# MANDATORY BULLETIN

No. L13/085a

Concerning: L13, L13A sailplanes

Reason: On the L 13 BLANIK sailplane S/N 027226, the tail-fuselage attachment fitting P/N A 102 021 N made of 424253.11 material has been damaged in service.  
The material of this component must be tested as instructed in this Bulletin.

Fig. 1

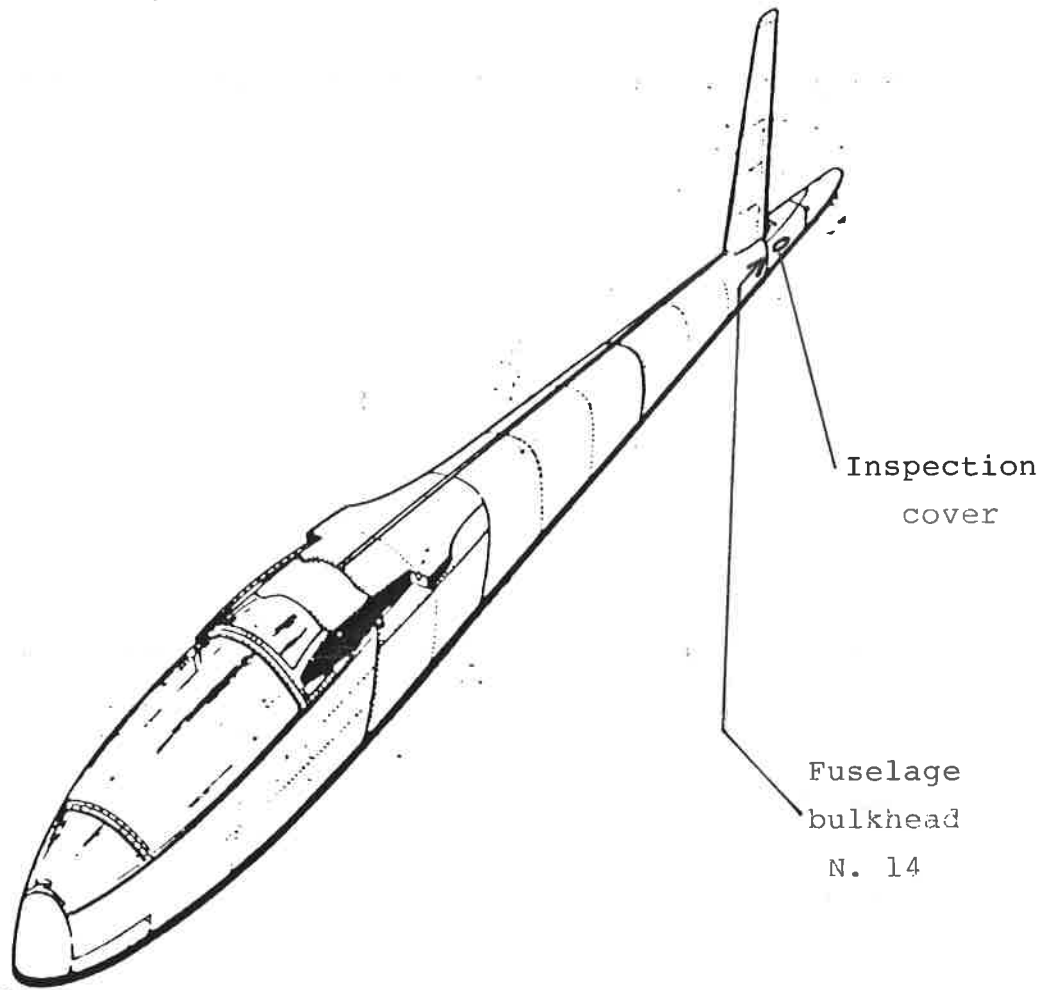
1. Remove the oval cover located on the LH side of the fuselage, under the horizontal stabilizer.
2. Test the material of the attachment fitting P/N A 102 021 N as follows:
  - a) Conductivity measurement by means of eddy currents:
    - Recommended measurement frequency: 60 kHz
    - Probe diameter: not exceeding 15 mm
    - Measuring contact point: lower milled surface of the component, between the rivets (see Figs 1 and 2).
